# REVISED HERITAGE IMPACT ASSESSMENT & CONSERVATION PLAN FOR 211-231 BANK

**Applications D02-02-22-0127 / D07-12-22-0188 and plan number 18910**

Revision 2: October 2024

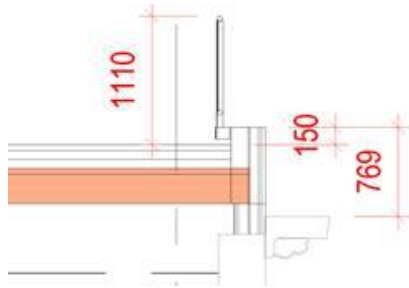
*The upper floors were intended to provide background vanilla and help focus on the podium and pedestrian scale of Bank Street. The planned Richcraft highrise towers adjacent to the site will overwhelm the nine storey and the distinction will further emphasis the foreground.*

This could be a red/brown or black accent colour that relates to the existing brick or cornice colour. This will help to integrate the new construction better to the Centretown HCD.

- Remove or push back the wall/railing above the second storey building along Bank Street.

*The height of the third level has been increased to maintain headroom. The bulkhead and railing have been set back, with the cornice standing proud of the façade. As illustrated by the image, the level (orange) is located above the cornice, we need to add a wall in this area anyway.*

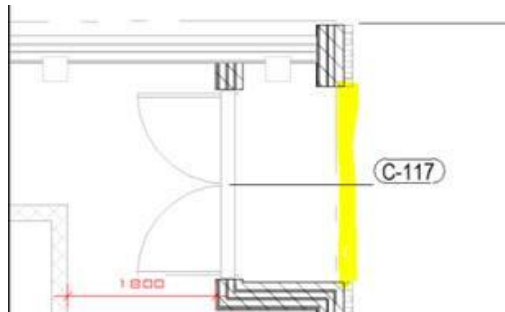
- Recess the Lisgar entrance to maintain the character of the carriageway. This feature was identified as a heritage attribute in the Conservation Plan and there are few left in the HCD, so should be respected.

*The doors have been set back but with the need for security and these alcoves being used for sleeping, would a metal grid used at night be acceptable (yellow highlight below)?*
